**COMMENTS AND OBSERVATIONS
ON THE DRILLING ACTIVITIES PERFORMED BY
EPA's TAT CONTRACTOR
AND SUBCONTRACTED DRILLER
DURING THE PERIOD OF
JUNE 23 THROUGH JUNE 27, 1992**

**UNITED PARK CITY MINES COMPANY
309 KEARNS BUILDING
SALT LAKE CITY, UTAH 84101**

**PIONEER TECHNICAL SERVICES, INC.
P. O. BOX 3445
BUTTE, MONTANA 59702**

JULY 13, 1992

FIGURE 1
WELL AND LANDFILL
LOCATION MAP

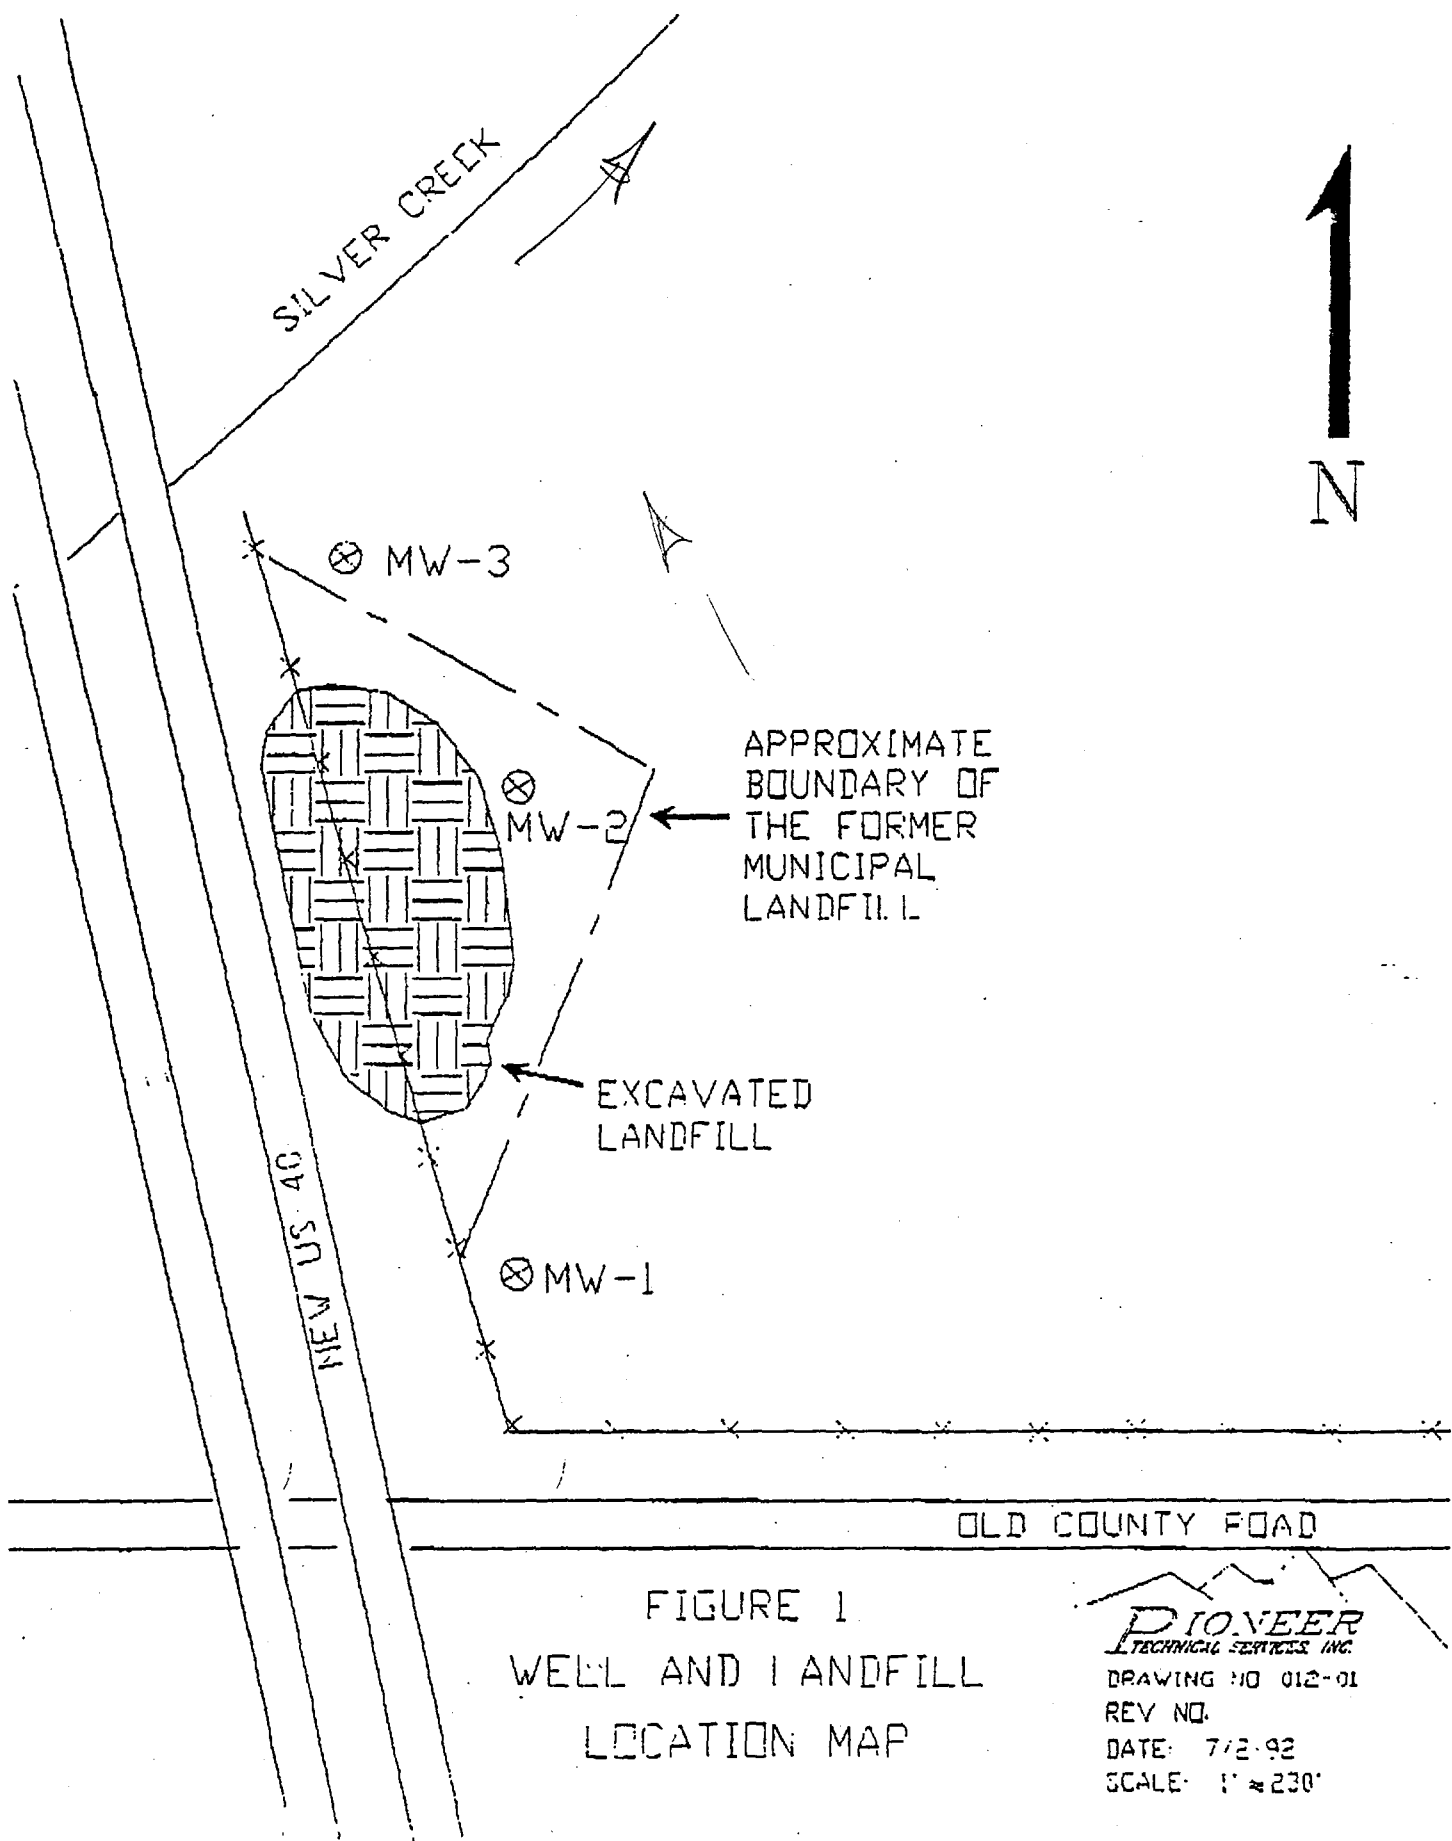
The most blatant violation of EPA guidance in the drilling of these monitoring wells was the placement of well MW-2 within the boundary of the historic landfill (see Figure 1). USEPA direction is clear - drilling directly through municipal landfills is to be avoided in order to protect underlying groundwater, and for obvious safety considerations; rather, drilling is to be conducted off of the actual landfill and downgradient from it. Prior to drilling, the TAT was advised by the property owner (UPCM) that the location selected for MW-2 was within the former landfill boundary. For whatever reasons, the TAT declined to relocate the well 100 feet to the north, out of the former landfill. After drilling five to ten feet, drill cuttings and split-spoon sample cores showed that the borehole was obviously within the landfill.

At this point, the proper procedure would have been to properly abandon the borehole, move off the landfill, and drill a new borehole in a safer location; however, the TAT persisted with drilling in the landfill. If TAT had adequate training and experience in hydrogeology, they would have anticipated the potential for problems arising from drilling through a landfill, and chosen to drill elsewhere. TAT's lack of experience and refusal to follow USEPA policy, resulted in one of the most serious monitoring well installation calamities possible (described below).

- first, not drilling within the landfill would have avoided breaching whatever natural, compacted liner might exist beneath it;

FIGURE 2
GEOLOGIC CROSS SECTION
AND LANDFILL MONITORING WELLS

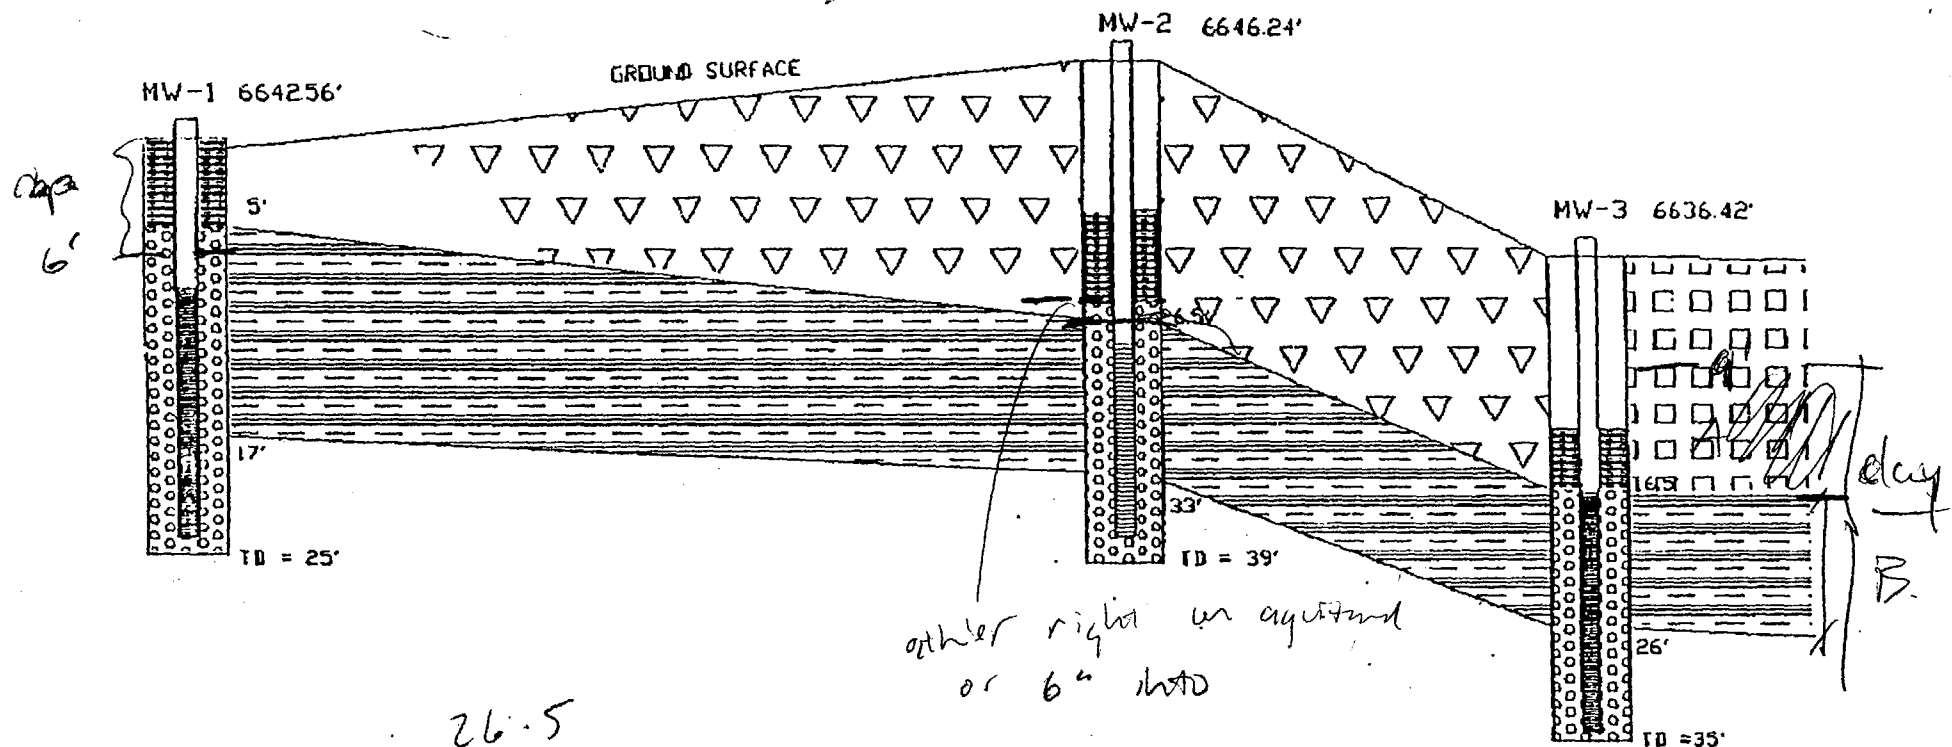
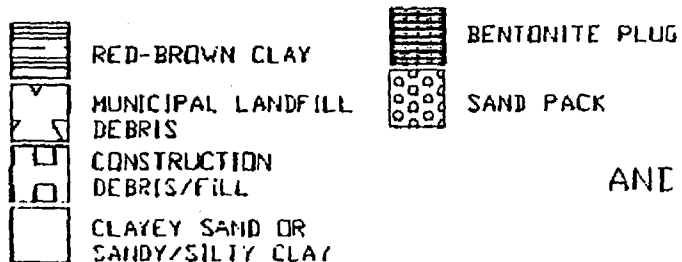
This is the most egregious violation of sound hydrogeologic practice and may have violated State of Utah regulations for monitoring wells, water wells, or groundwater protection. The drilling of all three monitoring wells showed that the underlying groundwater was a confined or semi-confined aquifer system. In each borehole, the saturated zones were found beneath a thick, apparently continuous aquitard that isolated the landfill materials from underlying groundwater system (see cross-section, Figure 2). In each of the three monitoring wells, the static water level rose to an elevation significantly higher than the level at which water was first encountered.

Borehole MW-1 (upgradient) first encountered this aquitard at 5 feet below ground surface (bgs) and the first groundwater at 16 to 18 feet below the surface (the base of the aquitard). The

borehole was deepened to 25 ft bgs and the well was completed; however, rather than installing 10 feet of screen to 15 ft bgs (near the first water), TAT put in 15 feet of screen, possibly interconnecting several discrete saturated zones. The following day, the water level had risen to only 8 feet bgs, clearly indicating that the underlying groundwater was under pressure.

After ill-advisedly locating well MW-2 within the former landfill (discussed above), drilling commenced. For whatever reason, the TAT did not closely monitor the drill cuttings from the borehole; however, UPCM's hydrogeologist was because of the geology observed at MW-1 and concern about breaching the aquitard underlying the landfill. At 25 ft bgs, a two-foot split spoon core revealed six inches of the aquitard (a reddish-brown clay) in the bottom of the core barrel, clearly showing the top of the aquitard to be at 26.5 ft bgs. The TAT erroneously recorded the top of this unit at 25 ft bgs. Drilling continued (slowly) and water was encountered between 34 and 35 ft bgs. The drilling was halted at 39 ft bgs and well completion activities began.

At this point, serious errors in judgment and perhaps criminal negligence, caused the completion of well MW-2 to be entirely inappropriate, if not illegal. First, 10 feet of screen were placed in the well, bringing the screened section up to 27.5 ft bgs, very close to the top of the aquitard unit. Then, the filter pack was brought up to 26 ft bgs, above the aquitard. The bentonite seal placed on top of the sand was intended to plug the aquitard; however, due to careless geologic logging, it completely missed the aquitard and provides no such seal. The formerly continuous barrier between the landfill materials and groundwater has been breached by the drilling and not repaired during well construction. Water level measurements on subsequent days show clearly that the underlying water is under pressure and has risen up the borehole to exactly 26.5 ft bgs, the top of the aquitard. The underlying groundwater is now flowing up the well under pressure, out through the filter pack along the top of the clay aquitard and into the base of the formerly dry landfill. When this water discharges from the base of the landfill, either as springs or to Silver Creek, it will be contaminated by whatever is in the landfill.

Prior to the installation of well MW-2, the landfill was isolated from the groundwater system. EPA and their TAT contractor have breached this natural compacted clay barrier and are thus solely responsible for the ensuing potential groundwater and surface water contamination.

The third well, MW-3, was moved further north at the urging of UPCM. During drilling, construction debris was encountered, but no municipal landfill wastes. This well encountered the same hydrogeology and was similarly misconstructured; however, the results are not as critical. The same aquitard (reddish-brown clay) was encountered in MW-3 at 16.5 ft through 26 ft bgs and water was again encountered beneath it. Instead of completing the well with the screened section at 26 to 34 ft bgs, TAT decided to place 15 feet of screen in this well, 5 feet into the aquitard. Filter pack was again placed in the borehole up to the top of the aquitard (16.5 ft bgs), and the bentonite seal above that, again missing the aquitard and not sealing the borehole. The result of this is again, the upward migration of formerly confined groundwater into the construction debris and eventually out of the filled area to surface water.

- secondly, careful geologic logging would have shown the aquitard unit to be between 26.5 and 33 feet bgs, and hence, no need to screen above 33 ft bgs; and,
- finally, the placement of screen and sand up to the base of the aquitard (33-38 ft bgs) and bentonite within the aquitard (26-33 ft bgs) could have maintained the integrity of the natural barrier between the landfill materials and the underlying groundwater system.

In any event, the serious nature of the well construction disaster described above is at least unprofessional and at worst illegal. I recommend that all of these wells be properly abandoned as soon as possible. It is especially critical that MW-2 be plugged so that it does not continue to flood the landfill.
